From: [Carolyn Lauron](#)
To: [Justin Hawkins](#)
Cc: [Greg Cranston](#); [Andrew Brenner](#)
Subject: NRC Staff Response to Clarification Question re: RHR System Classification (99902049)
Date: Friday, May 26, 2023 11:16:00 AM
Attachments: [image001.png](#)

Question:

Is SMR-160 appropriately classifying the RHR system, specifically the portions of the RHR system outside of the containment boundary as Quality Group D, based on the information and context provided below?

Figure 1: SMR-160 RHR RG 1.26 Quality Group Classification

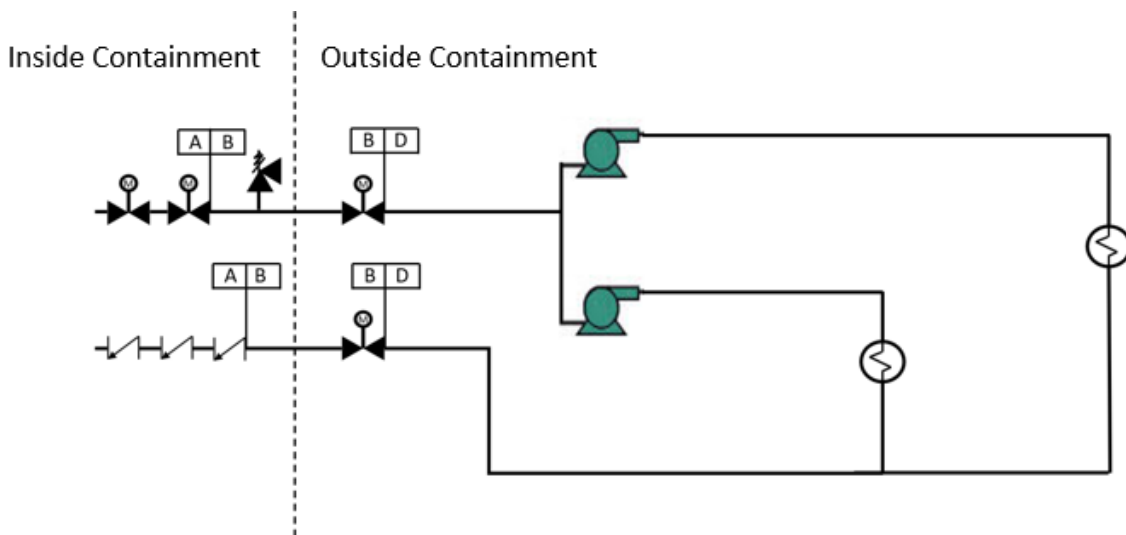
Criterion a. for Quality Group C does not apply to the remaining portions of the RHR system outside of the containment boundary as they do not serve any safety related or, based on preliminary SMR-160 PRA results, important to safety residual heat removal functions.

automatic closure isolation valves. However, criterion c. for Quality Group C similarly does not apply to the remaining portions of the RHR system outside of the containment boundary due to note 5. The RHR system containment isolation valves serve as the additional valve that has high leaktight integrity. While the RHR system circulates coolant outside the RCPB and could be considered more than just an influent line, such a consideration is not applied to the Quality Group D portions of the AP1000 chemical and volume control system, which also circulates RCS coolant outside the RCPB during coolant purification [2]. The NRC specifically states that the AP1000 chemical and volume control system meets “GDC 1 and RG 1.26 by assigning quality group classifications to system components in accordance with the important to safety function to be performed” [3]. **Therefore, the portions of the RHR system outside of the containment boundary are also justified as Quality Group D.**

Based on the NRC evaluation of the term “important to safety” as described in the *Federal Register* notice, probabilistic risk assessment (PRA) results may not be used to remove a component from the classification of important to safety in a nuclear power plant. PRA results may be used to determine that a component has low safety significance compared to other components for a particular nuclear power plant design. For components in a nuclear power plant, the applicant must satisfy the NRC regulations applicable to the safety functions of each component.

In response to the specific question from SMR, LLC (Holtec), the NRC staff does not consider it appropriate to rely on the quality group classification of the CVS in the AP1000 design to justify the quality group classification of the RHR system in the SMR-160 design. SMR, LLC (Holtec) will need to justify its proposed quality group classification of the RHR system for the SMR-160 based on its specific functions and safety significance as part of an application submitted for review by the NRC staff. SMR, LLC (Holtec) might request a meeting with the NRC staff in the reactor systems, mechanical engineering, and PRA branches to discuss the specific functions and safety significance of the RHR system for the SMR-160 in determining its appropriate quality group classification.
